**DELEGATED AUTHORITY REPORT FOR A COMBINED DEVELOPMENT APPLICATION FOR A DEVELOPMENT PERMIT FOR A MATERIAL CHANGE OF USE (CODE ASSESSMENT) FOR MULTIPLE DWELLINGS (186 UNITS) OVER PROPOSED LOT 1 AND LOT 2 AND DEVELOPMENT PERMIT FOR RECONFIGURING A LOT (CODE ASSESSMENT) FOR A 1 INTO 2 LOT FREEHOLD SUBDIVISION, BALANCE LOT, NEW ROAD AND TEMPORARY ACCESS EASEMENT OVER APPROVED LOT 900 AT 54 GEORGE ALEXANDER WAY, COOMERA
COM/2024/236**

Application information	
Address	54 George Alexander Way, Coomera
Lot and plan	Lot 96 on RP187418
Site area	30,100m ²
Type of development and proposed use	Combined application for: - Development permit for Material change of use for Multiple dwellings (186 units) over proposed lot 1 and 2; - Development permit for Reconfiguration of a lot for a 1 into 2 lot freehold subdivision, creation of a balance lot, new road, and temporary access easement over approved lot 900.
Categories of development and assessment	Code assessment
Properly made date	21 August 2024
Decision due date	28 November 2025
Applicant and Applicant's consultancy team	Saunders Havill Group – Applicant, Town Planning, Landscape Architecture & Ecology Archipelago – Architect Colliers – Traf

Figure 3: Officer markup of the two-stage delivery of Talpa Street (Source: Officers materials)

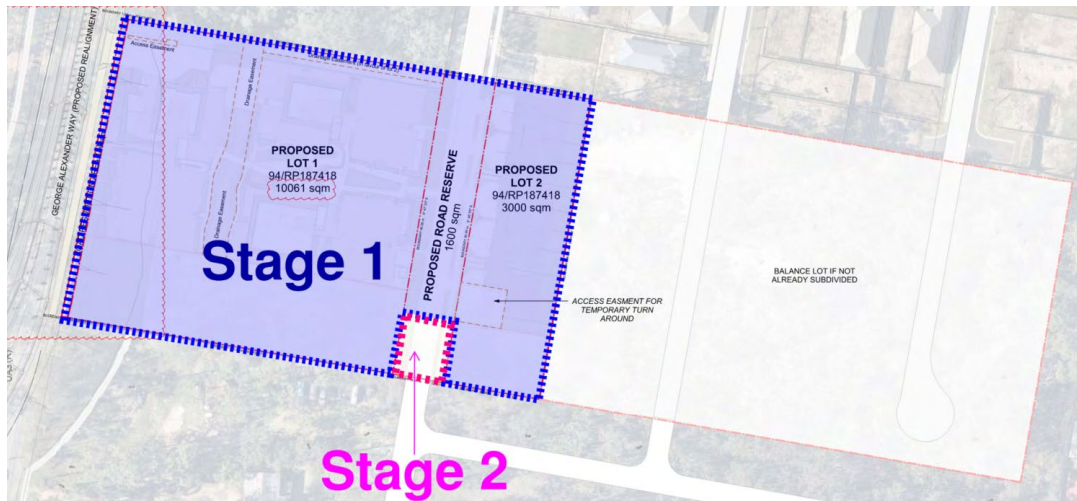
Approved lot 900 is proposed to be subdivided into two lots - Proposed Lot 1 and Lot 2. Between Proposed Lot 1 and Lot 2 is a new road, which is an extension of Talpa Street to the north. The applicant has proposed delivery of Talpa Street in two stages; however, the ROL plan does not incorporate a staging plan. Therefore, officers have conditioned amended drawings. The markup showing the staged delivery of Talpa Street is shown in Figure 3 below.

The staged delivery of Talpa Street is deemed essential as there is no temporary turning head at the end of stage 2 of the ROL component (and also at the end of stage 2 of the MCU component). Therefore, the development relies on future development to the south to provide either a turning head or road connectivity to enable vehicles to egress back into the local network. Accordingly, the temporary access easement and turning head must be maintained until these roadworks are completed. To achieve this, the ROL component must be delivered in sequential order in accordance with the officer markup.

Furthermore, to ensure safe operation of the local road network, the ROL component has been conditioned to implement a staged delivery of Talpa Street through an amended drawings condition. The absence of a permanent turning head at the end of Stage 2 (for both the ROL and MCU components) makes the development reliant on future development to the south to provide either a dedicated turning head or future road connections to the surrounding local road network. This provision is essential to enable Refuse Collection Vehicles (RCVs) to safely manoeuvre within the road reserve and egress back into the local network. Accordingly, the conditions enforce that the existing temporary access and turning head must be maintained until the neighbouring works on the southern lot (96RP187418) are completed, and that the ROL component must be delivered in sequential order in accordance with the staging plan to manage this dependency and maintain safe vehicle operation.

Figure 27: original road widening sketch (Source: officer materials)

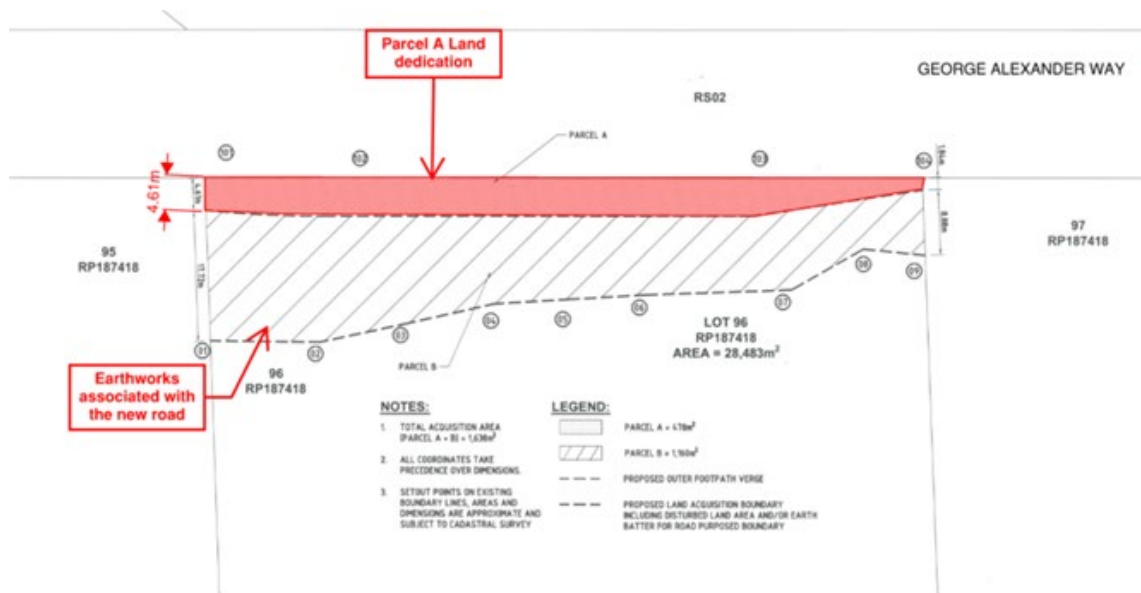
Due to a significant 3m change in height associated with the ultimate road upgrade (which connects to the four-lane Foxwell Road), the applicant could not achieve a suitable interim access outcome. The interim driveway arrangement was ultimately removed from the proposal as it was determined to be too complicated and would result in the interim driveway being sacrificial. The opening of Stage 2 is therefore aligned with the ultimate George Alexander Way upgrade, scheduled for completion by late 2027 brought forward from 2031.

Regarding the driveway access to George Alexander Way, a new 10m-wide crossover is proposed to align with the ultimate trunk road alignment for George Alexander Way. In the Information request, officers requested access to George Alexander Way be restricted to left-in and left-out only, to be consistent with the prior approval COM/2023/16 condition 18, which also required a 0.6m median island due to safety concerns due to proximity to the intersection with Foxwell Road. Initially, the applicant proposed stage 2 (Multiple dwellings-apartments) access to Talpa Street. Officers were concerned that this would increase the daily traffic above the desirable 750 vehicles per day. Officers therefore requested the applicant to amend the design to relocate stage 2 access to George Alexander Way.

After receiving the Applicant's response to Information request, further discussions were held regarding the land dedication amount and the distance to the intersection with Foxwell Road. Ultimately, officers from the Transport Assessment Planning and Management (TAPM) team supported all-movement access on this two-lane section of George Alexander Way without requiring a dedicated right turn lane. Upon further review, it was deemed that the vehicle crossing is positioned to provide adequate sight distance for approaching vehicles in both directions—north and south. During the critical afternoon peak hour, officers expect a demand of one vehicle turning right every 1-2 minutes. Subsequently, the final road design results in a total width of 5.5m that is available between the centreline and kerbline, comprising a 3.5m travel lane and a 2m bike lane, as shown on the design drawings to be marked with yellow lines. This allows for passing northbound through vehicles. Officers have not conditioned an OPW for a non-standard VXO to George Alexander Way noting that this is a significant project being undertaken as part of the Coomera state hospital project due for completion in late 2027. However, the applicant is aware that a future OPW is required for the vehicle access. References to left-in and left-out have been crossed off the architectural drawings.
